CMD: 22-H2.B

Licence Renewal
Commission Request for Information

**Point Lepreau Nuclear
Generating Station**

Submitted by:
CNSC Staff

Figure 2: Global mean sea-level rise estimates [16]

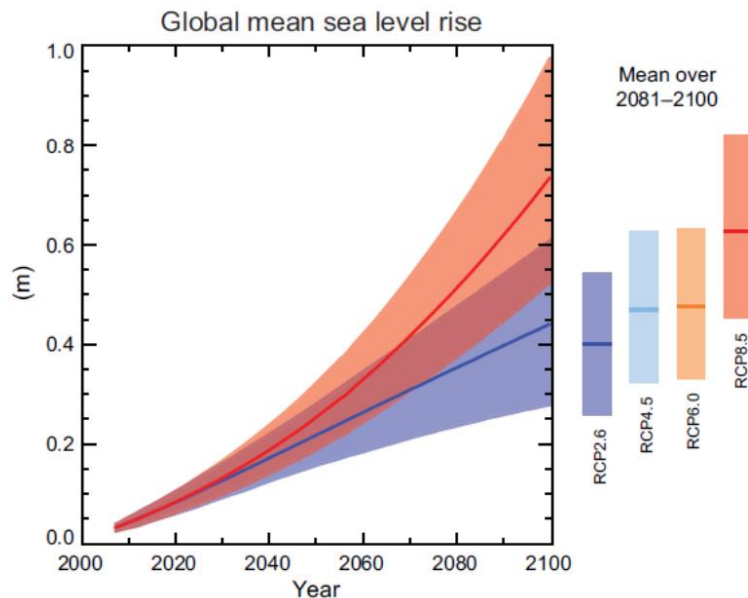
According to page 72 of the [transcript](#) from the January 26, 2022, Public Hearing, Commission members mentioned that the climate is changing fairly radically. Commission wanted to know how climate change factors are considered with regards to long term operations.

Specific to NB Power, CNSC staff examined the licensee’s climate resilience. As an example of the conservatism in the assessment, the worst-case emission scenario climate model [15] projects that global mean sea level will likely rise by ~0.8 metres by 2100, as shown in Figure 2 below. CNSC staff conservatively assumed one (1) metre of sea water level rise at the Bay of Fundy when reviewing NB Power’s tsunami flood hazard assessment for the Point Lepreau NGS. CNSC staff conservatively applied the 80-year projected climate change effects on tsunami flood to the proposed 20-year licence period and concluded that Point Lepreau NGS is protected from potential external flood hazards and is resilient to the current and projected climate change conditions.

Therefore, there are no expected safety impacts related to climate change over the proposed 20-year licence period.

Figure 3: Fuel defects during current licensing period

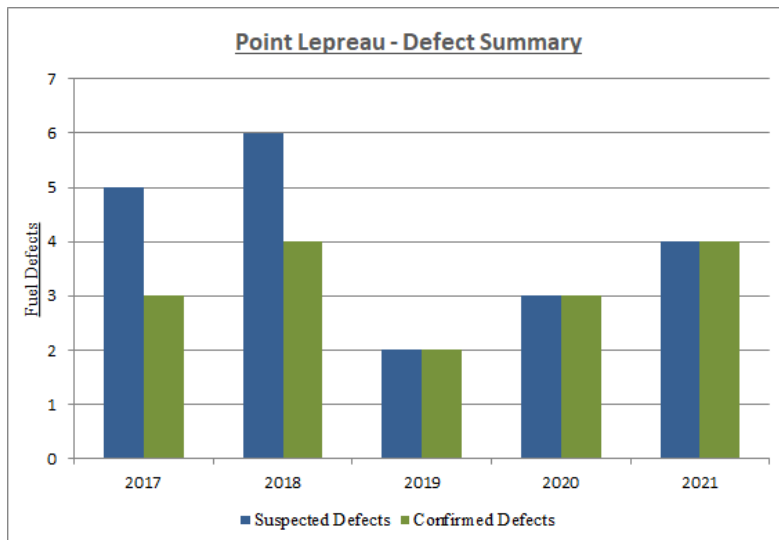
CNSC staff requested that NB Power provide their strategy to address the elevated fuel defect rates at the Point Lepreau NGS, which had trended above the expected rate of 1 defect per unit per year as shown in Figure 3: Fuel defects during current licensing period. NB Power clarified that the fuel defects may have been caused by foreign material introduced by outage work on the primary heat transport system in loop 2. CNSC staff confirmed that NB Power has established a response strategy including increased fuel inspections and is working with a third party to address the root cause of the issue.

CNSC staff note that the fuel defects are normally located and discharged within 3 months of becoming defective. The defects are small, and the I-131 limits have not been exceeded. Figure 3: Fuel defects during current licensing period reflects the number of fuel defects which were detected by monitoring the PHT radionuclide concentrations (suspect defects) and the number of defects confirmed by fuel bay visual inspections (confirmed defects). Inspections in the fuel bay have observed some fuel bundles with small wire like pieces of debris trapped in them.

Even though the defect rate is higher than the typical one per unit per year, it is still low. Historically, debris in the PHTS has not been “removed” by any dedicated means. Early industry attempts at using strainers failed because the strainers degraded and produced more debris. Over time, the PHT pumps will typically break up the debris into smaller pieces which will be less damaging to the fuel, with some debris settling out into low flow sections of the system, and some will be removed from the system through fueling actions. It typically takes 5-8 years for the system to “self-clean” and return to normal.
